CHAPTER FIFTY-EIGHT SPECIAL DESIGN ELEMENTS

58-1 ACCESSIBILITY STANDARDS FOR THE DISABLED

Summary of Comments on Chapter_58_Changes 080702.pdf

SIDEWALKS AT DRIVEWAY APRONS
Figure 58-1D

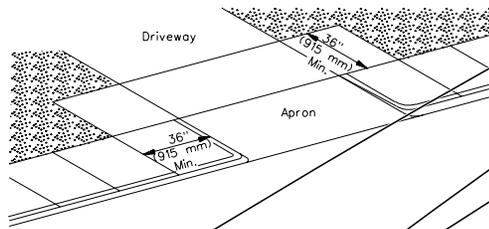
- 3. Separation. Sidewalks adjacent to the curb or roadway may be offset to avoid a non-conforming cross slope at driveway aprons by diverting the sidewalk around the apron; see Figure 58-1D.

+	Author: Lkirchler	Subject: Cross-Out	Date: 6/17/2008 12:32:54 PM
T	Author: Lkirchler can	Subject: Inserted Text	Date: 6/17/2008 12:32:38 PM
E	Author: Lkirchler	Subject: Replacement Text C	Date: 6/17/2008 12:33:03 PM
+	Author: Lkirchler	Subject: Cross-Out	Date: 7/1/2008 7:39:05 AM
T	Author: Lkirchler	Subject: Inserted Text Sidewalks Not Currently Part of Accessible Routes	Date: 7/1/2008 7:39:39 AM
+	Author: Lkirchler	Subject: Cross-Out	Date: 6/17/2008 12:33:37 PM
T	Author: Lkirchler	Subject: Inserted Text Note: Sidewalks on the public right-of-way may be part of an accessible route in the future as land use changes. These changes should be planned for in current construction projects.	Date: 7/1/2008 7:41:12 AM
E	Author: Lkirchler	Subject: Replacement Text 20	Date: 6/17/2008 12:34:13 PM
T	Author: Lkirchler	Subject: Inserted Text up to 1V: 12H	Date: 6/17/2008 12:34:30 PM
E	Author: Lkirchler	Subject: Replacement Text If the longitudinal slope of the adjacent street is such that providing a 1V: 12H ramp would exceed 15 feet, a steeper ramp could be allowed.	Date: 6/17/2008 12:35:25 PM

E	Author: Lkirchler	Subject: Replacement Text accessible	Date: 6/17/2008 12:35:44 PM
E	Author: Lkirchler	Subject: Replacement Text and fixed	Date: 6/17/2008 12:36:16 PM
